# Service Bulletin

Bulletin No.: 17-NA-201

**Subject: Excessive Windshield Condensation, HVAC Defrost Door Flutter Type Noise Heard**

Brand:	Model:	Model Year:		Breakpoint:		Engine:	Transmission:
		from	to	from	to		
Chevrolet	Camaro	2016	2019	SOP	April 01, 2017* *Vehicles built after this date DO NOT have pads on the HVAC defrost doors.

4784132

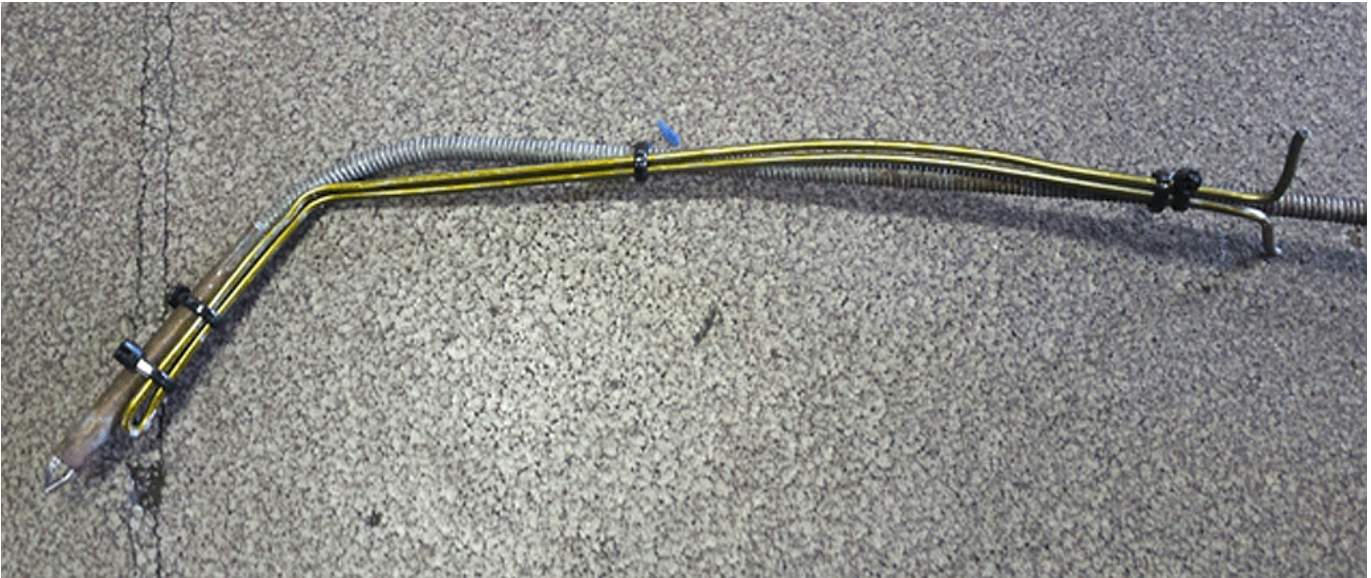
Bend the wire 120°, as shown above, and zip tie the grippers/fingers tool to hold the shape/angle needed to reach the foam pads on the defrost door.

**Note:** It is important to have the ends of the wire bent outwards to provide a handle to help maneuver the fingers into place.
